Addendum #1

11/21/22

**project: Intermountain Healthcare
Layton Hospital – CT Remodel
201 Layton Parkway
Layton, UT 84041**

PROJECT: Layton Hospital CT Addition.

SHEET TITLE AND NUMBER:
M103
 LEVEL 3 HVAC PLAN

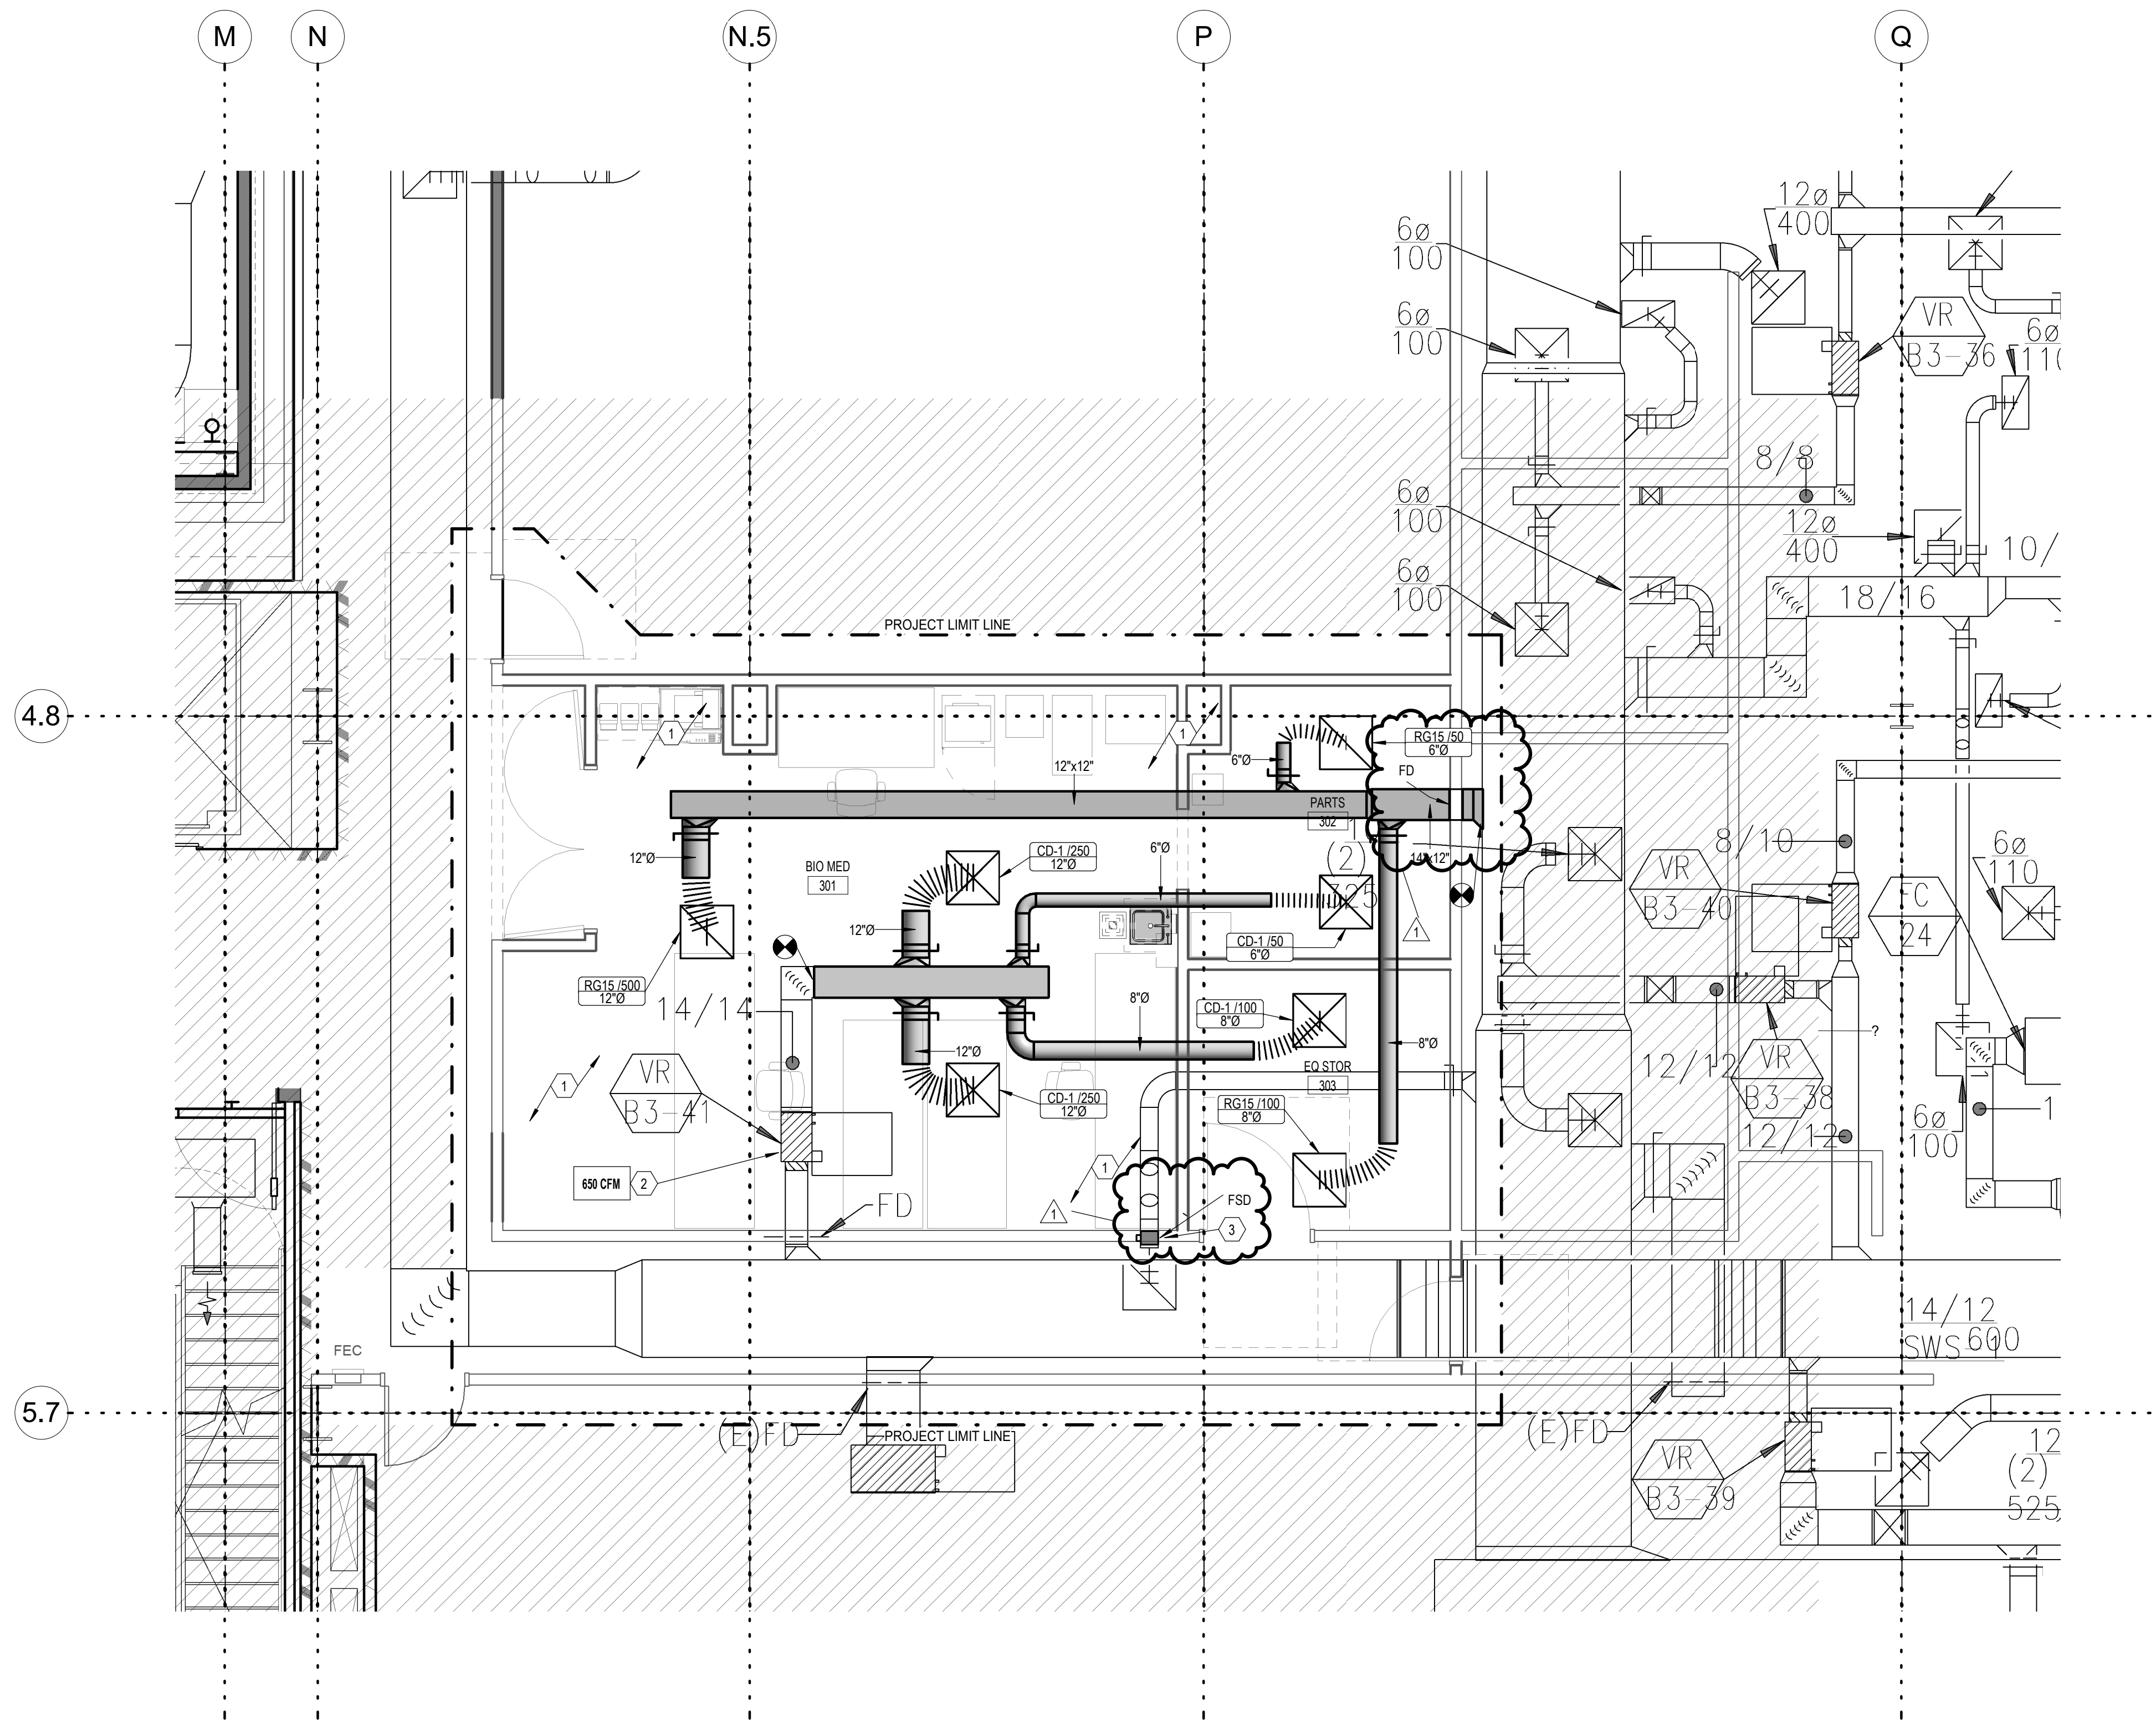
SHEET - M103

1. Showed new combination fire/smoke damper being added in place of existing fire damper at duct serving corridor.
2. Added fire damper at return duct serving Bio Med.

SHEET TITLE AND NUMBER:
EY102
 LEVEL 3 AUXILIARY PLAN

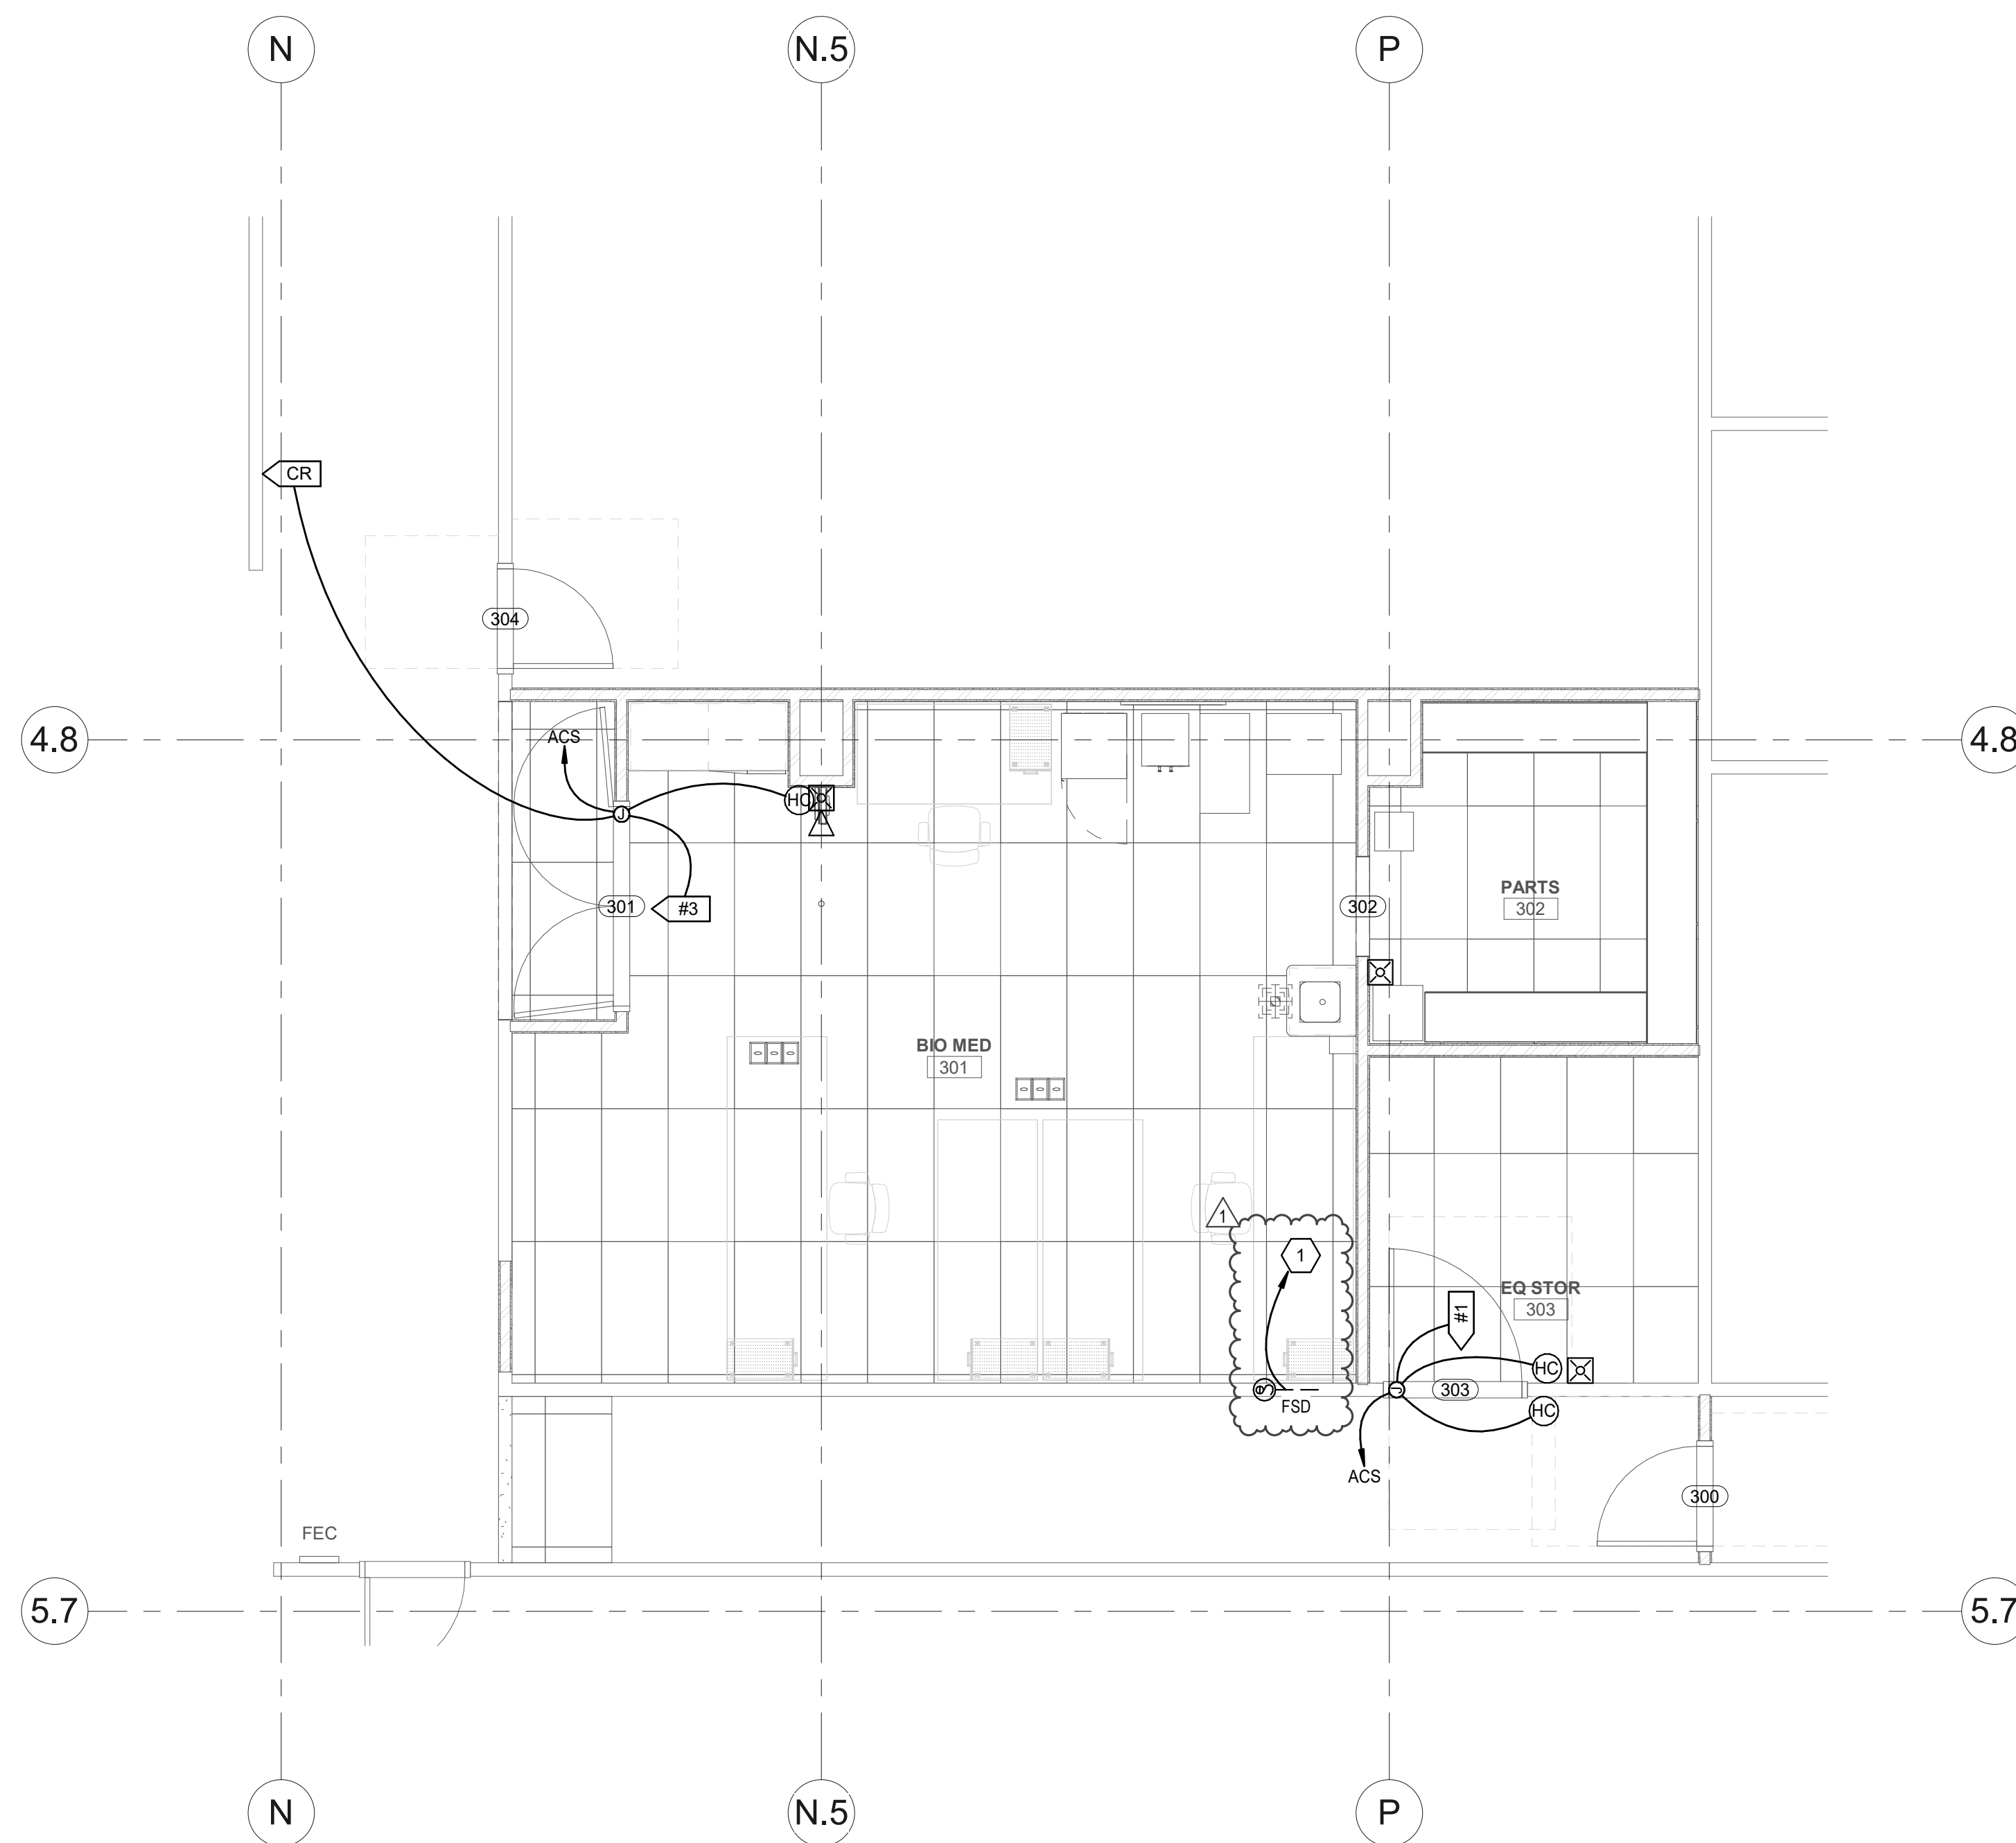
1. EL601 – Interior Lighting Fixture Schedule
 - a. Changed DX-20D to be dim to dark.
 - b. Added additional approved fixtures.
2. EY102 – Level 3 Auxiliary Plan
 - a. Added fire smoke damper to be connected to existing fire smoke damper circuit.

- 1 CONNECT TO EXISTING FIRE SMOKE DAMPER CIRCUIT ON THIS FLOOR IN THE ELECTRICAL ROOM.
